ADDENDUM NO. 1

DATE OF ISSUANCE: April 12, 2024

PROJECT: 2024 Addition and Renovations
North Harrison Elementary School
1115 W. Whiskey Run Road
Ramsey, IN 47166

ARCHITECT'S PROJECT NO.: 23-228.001

SHEET TITLE
PLUMBING FLOOR PLAN - UNDERSLAB RENOVATION

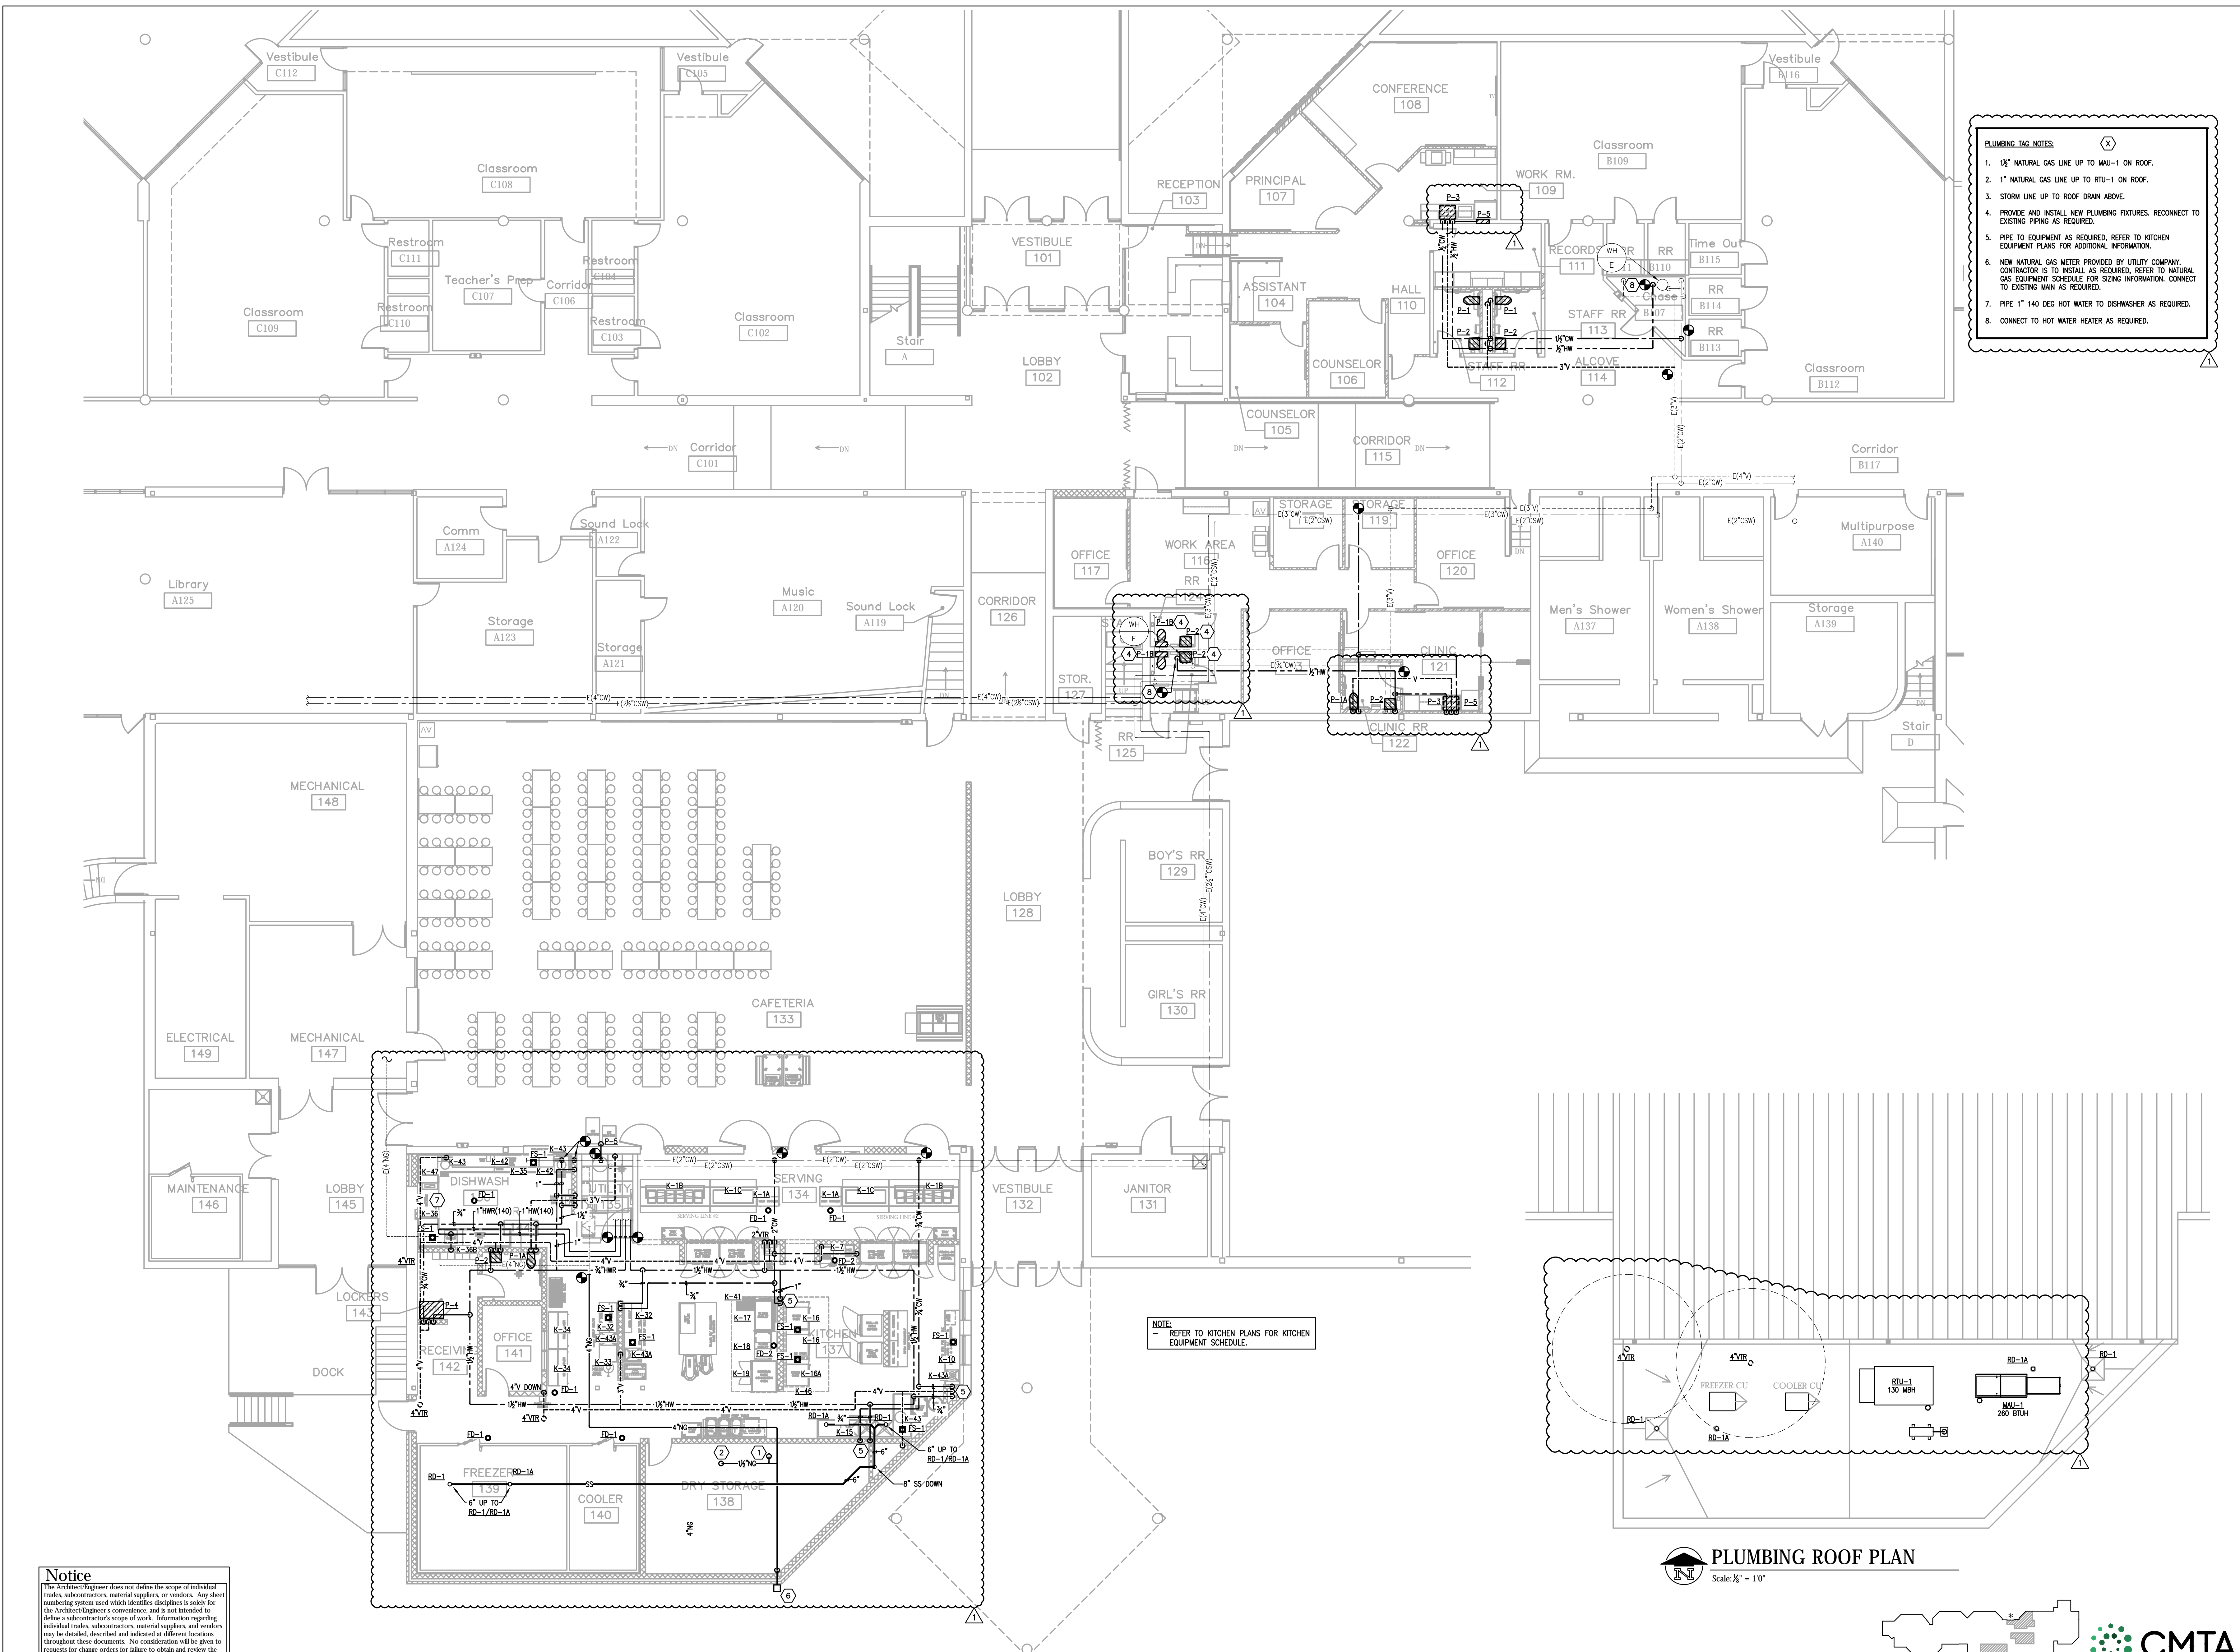
ADD-1 Item No. D-8 - Plumbing Floor Plan – Underslab Renovation

Refer to Sheet(s): P300

- Replace with attached revised Drawing in its entirety; revisions have been clouded for reference.
- Added information about the grease trap size.

SHEET NUMBER
E200A

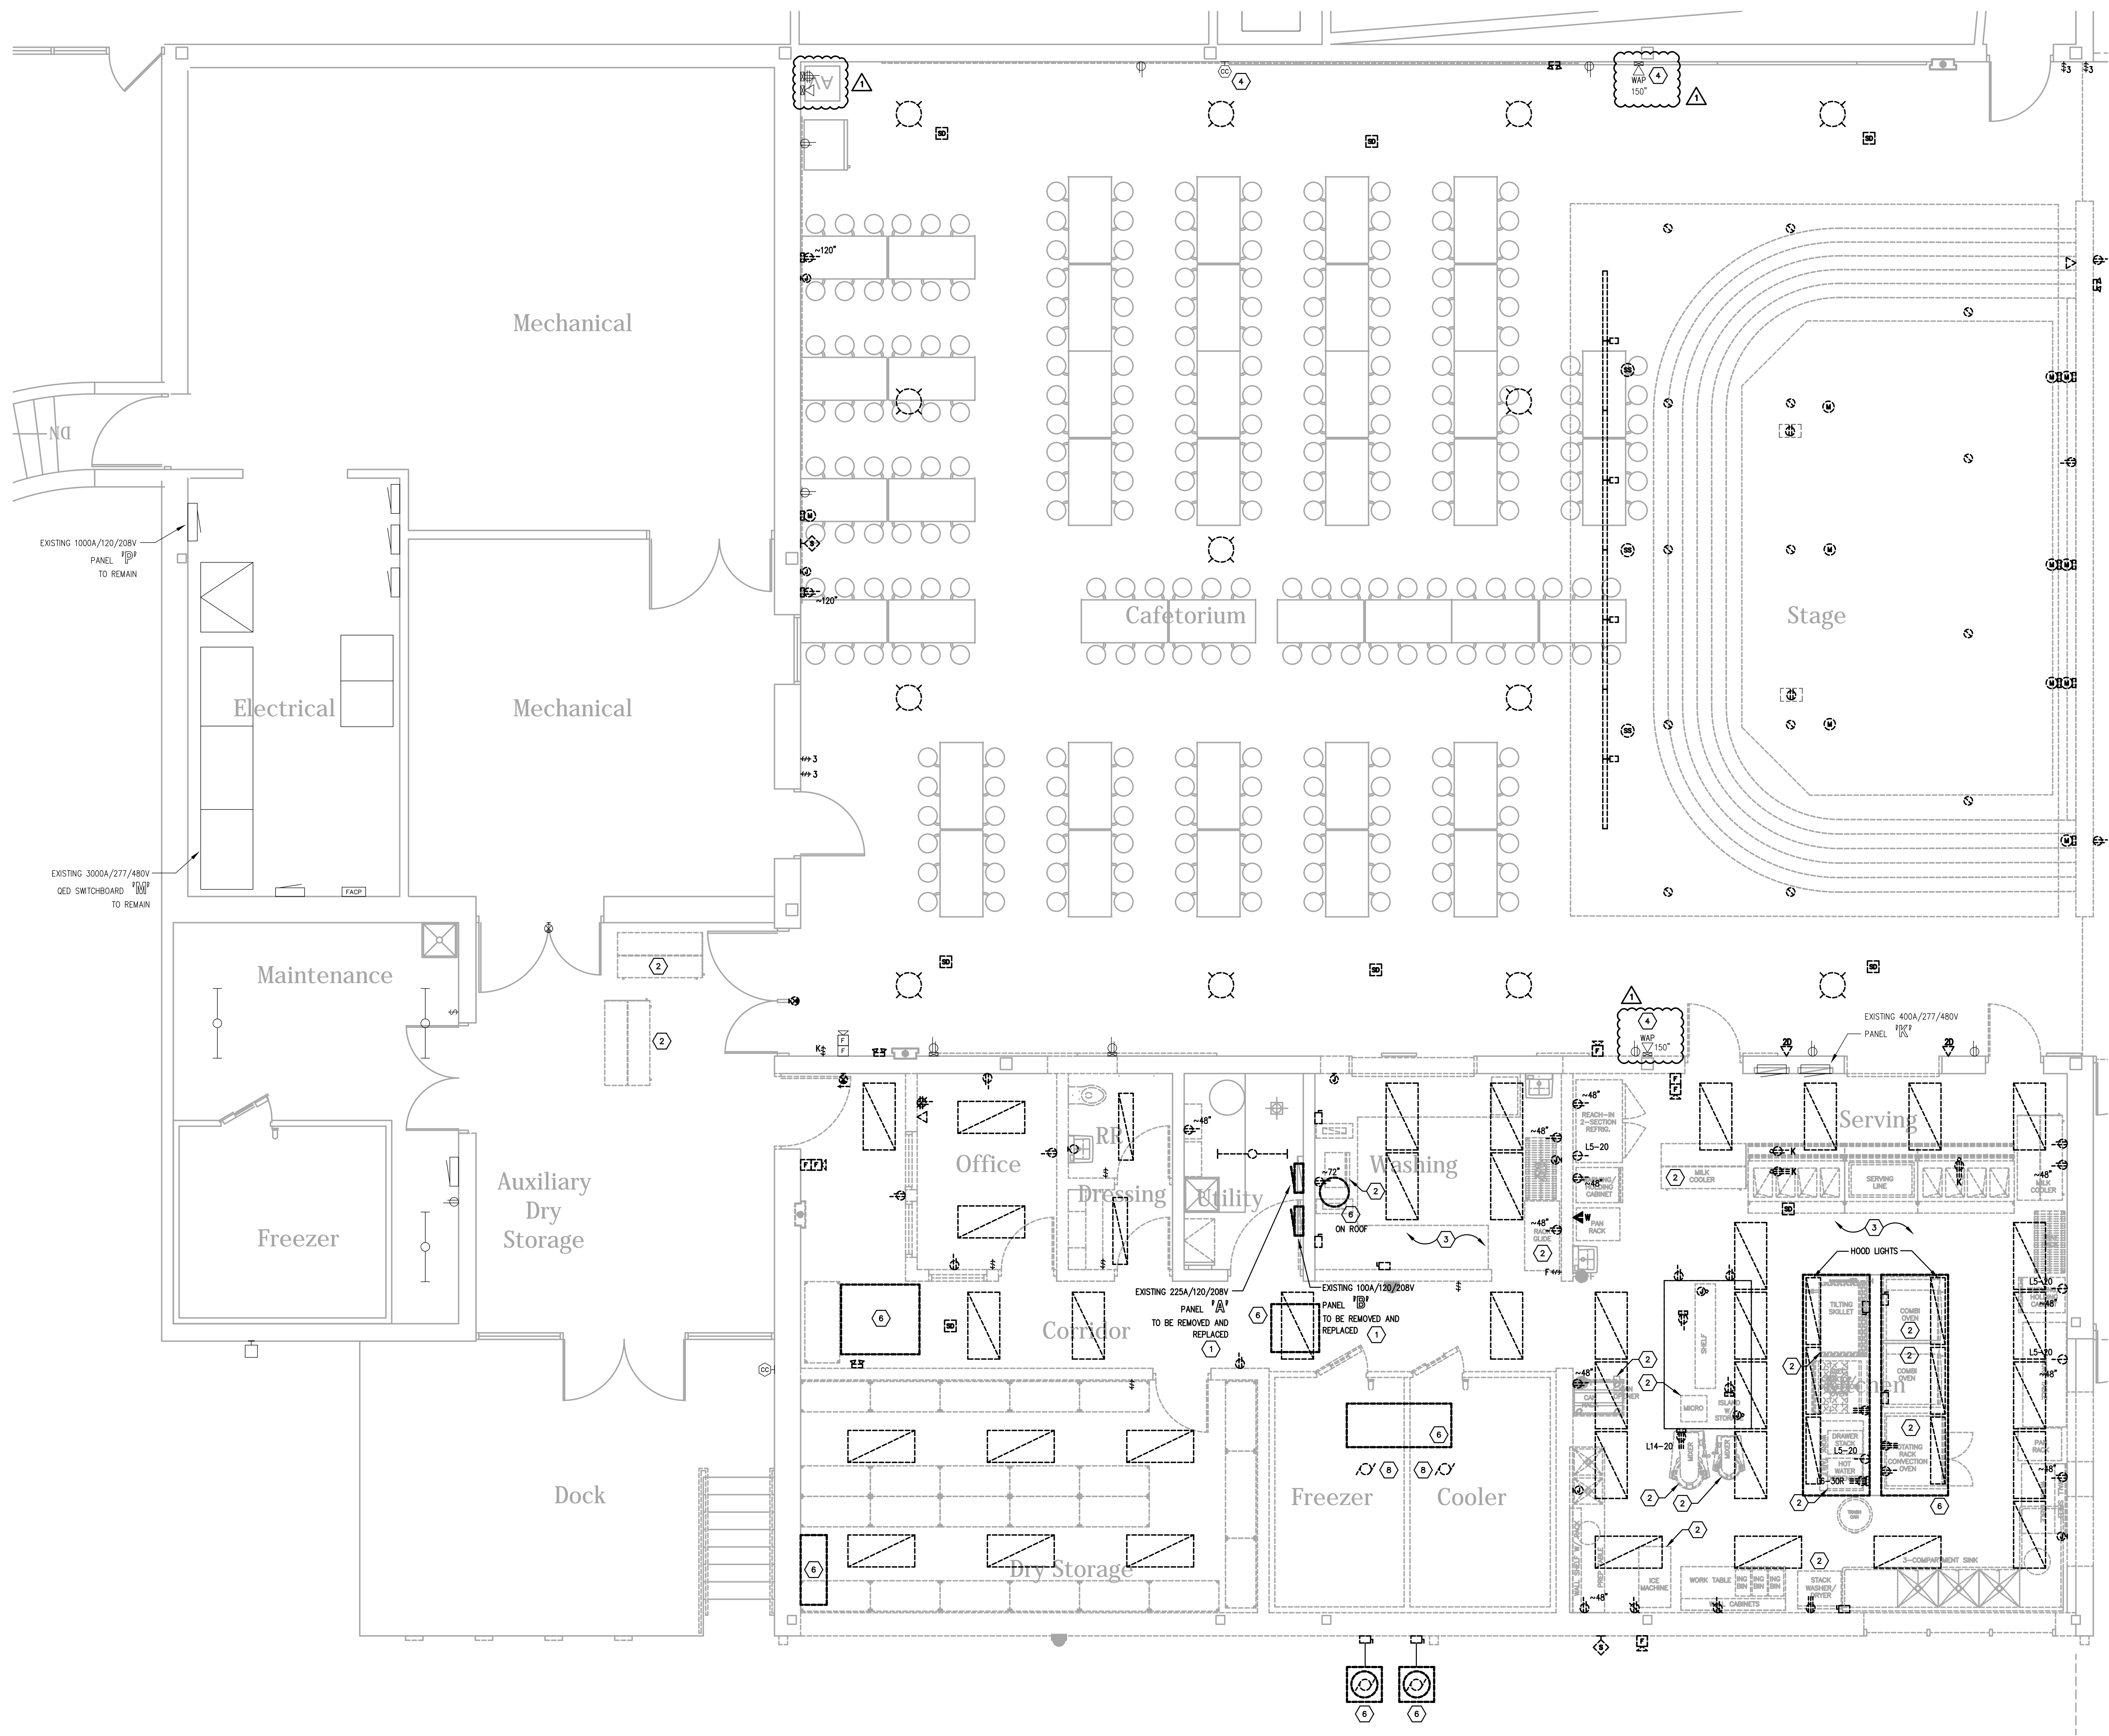
ADD-1 Item No. D-16 - Walk-In Compressors

Refer to Sheet(s): E200A

Revised tagged note #8 to indicated compressors shall be "removed and replaced onto new roof" rather than reinstalled.

SHEET TITLE
 PARTIAL FIRST FLOOR PLAN -
 LIGHTING - AREA B
 SHEET NUMBER
E300B
 DATE
 APRIL 3, 2024

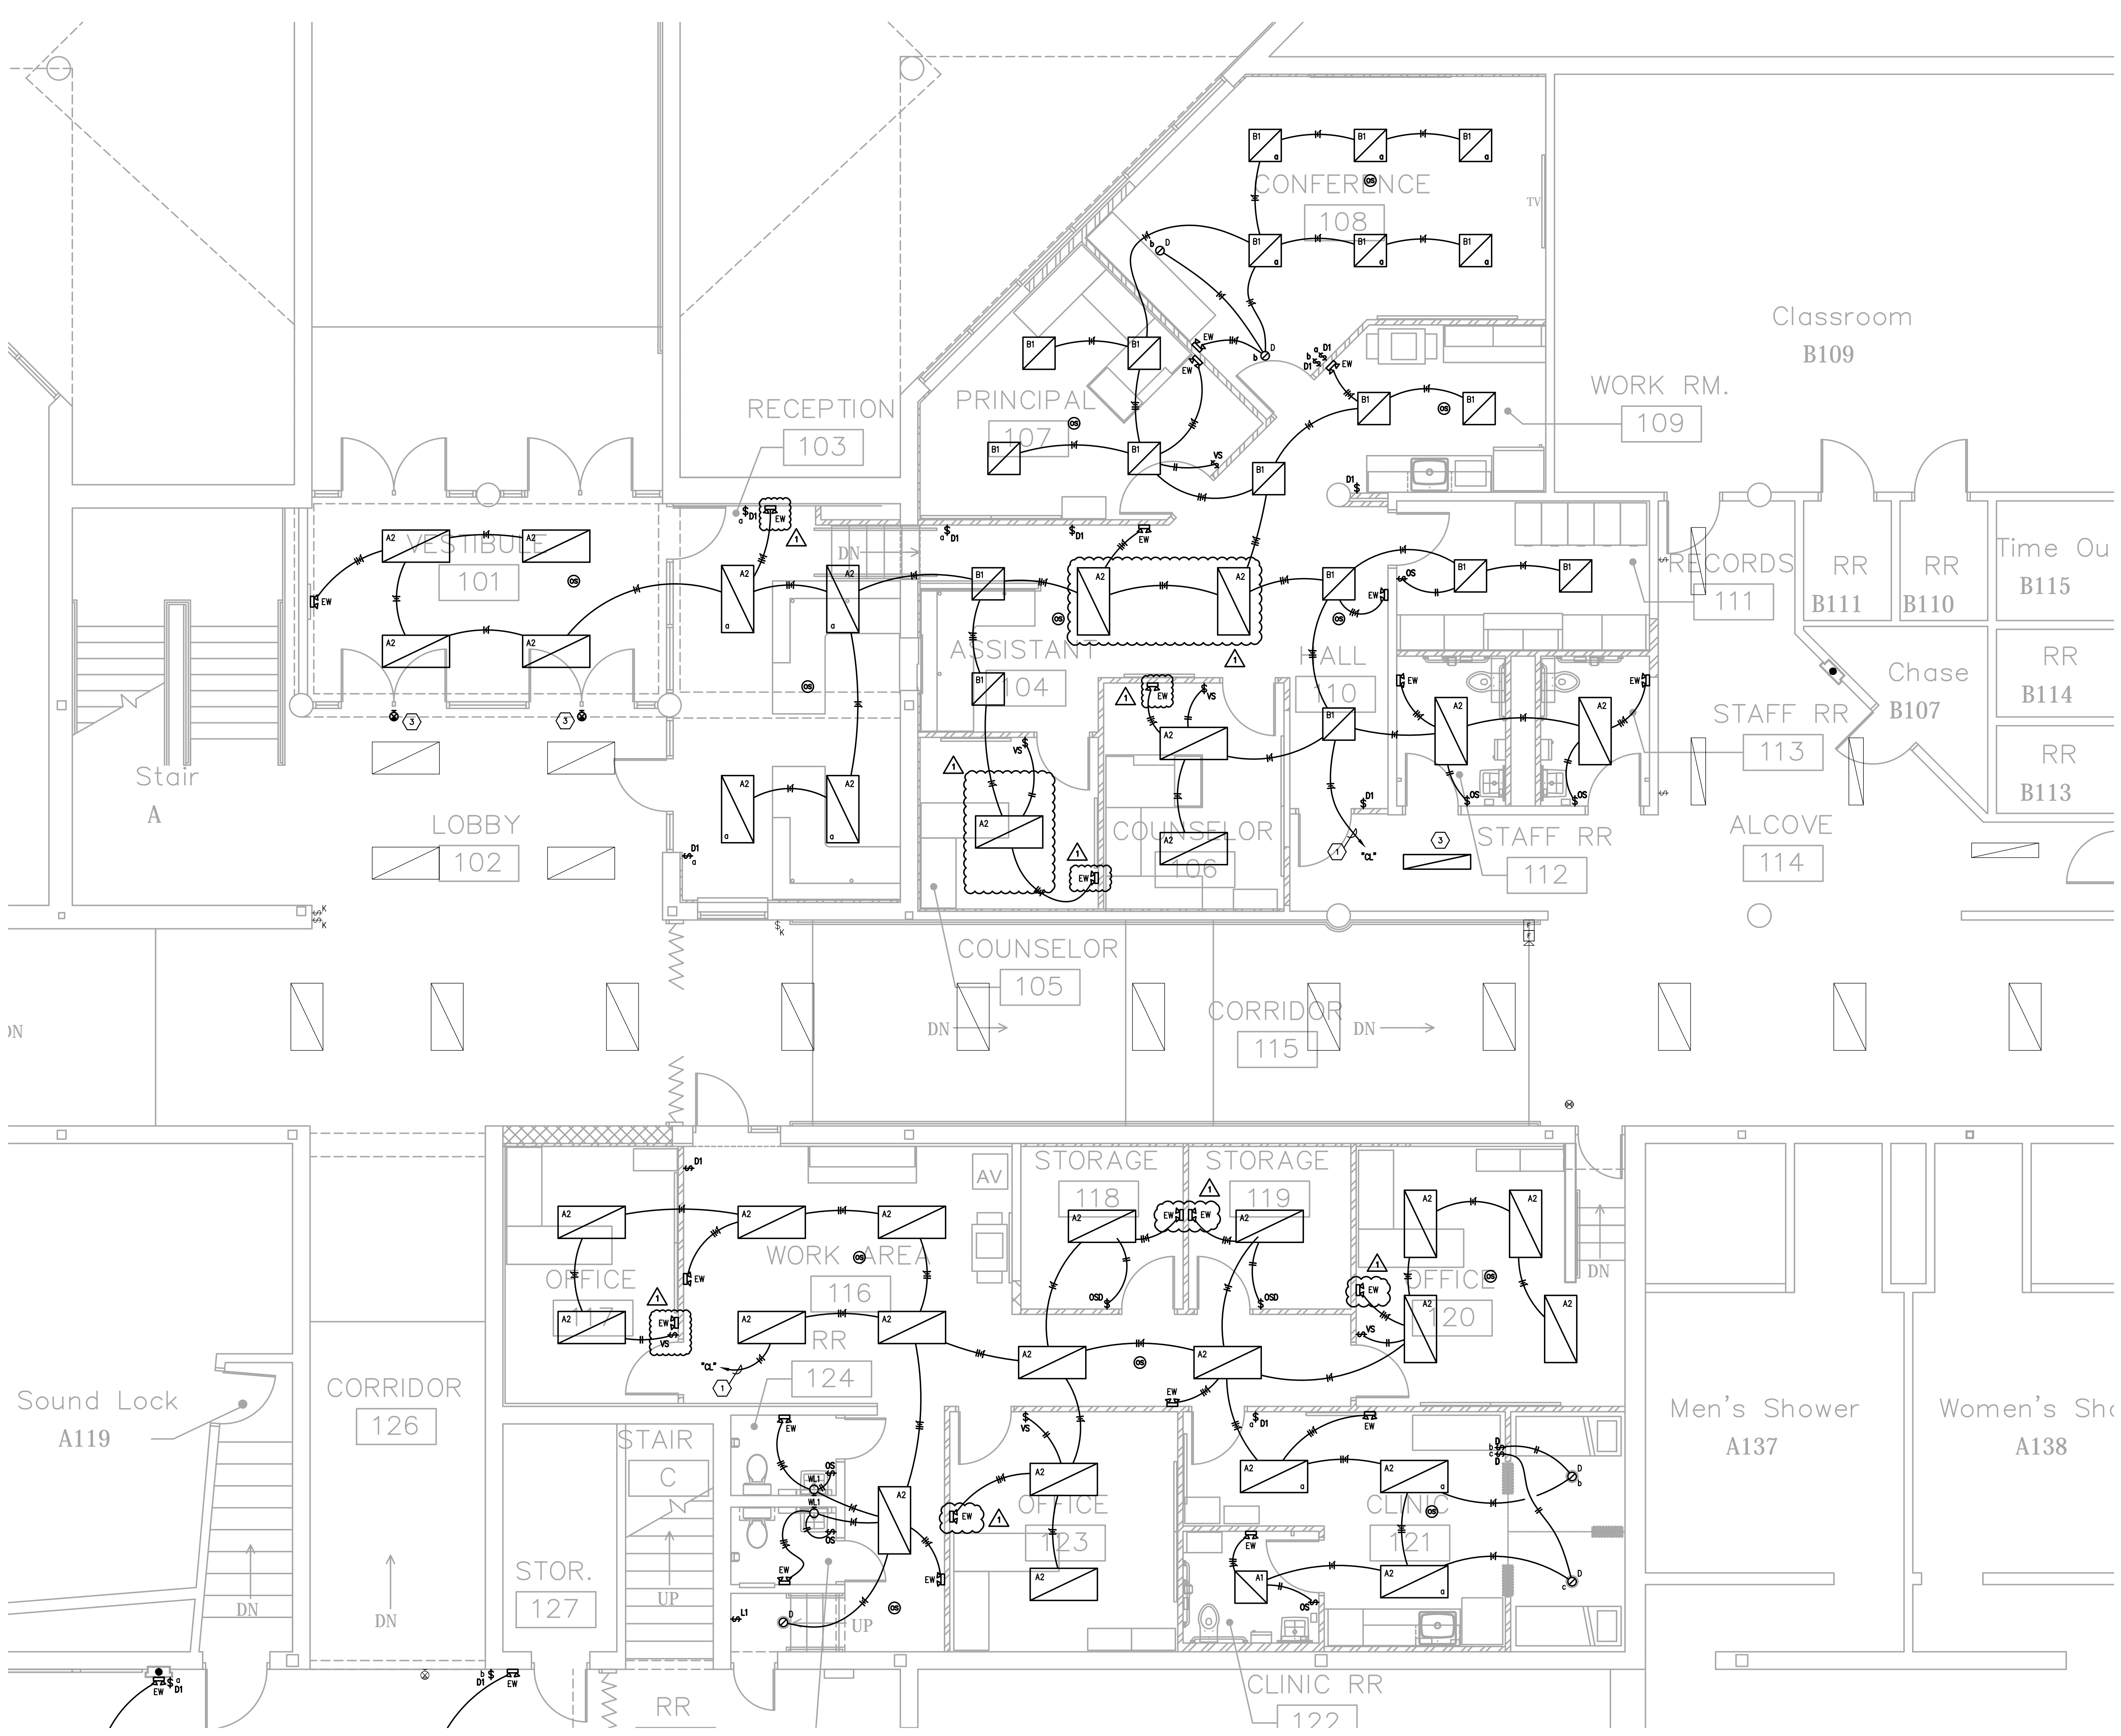
ADD-1 Item No. D-22 - Cafeteria WAPs

Refer to Sheet(s): E300B

Delete [2] new WAP's indicated on plan west side of cafeteria.
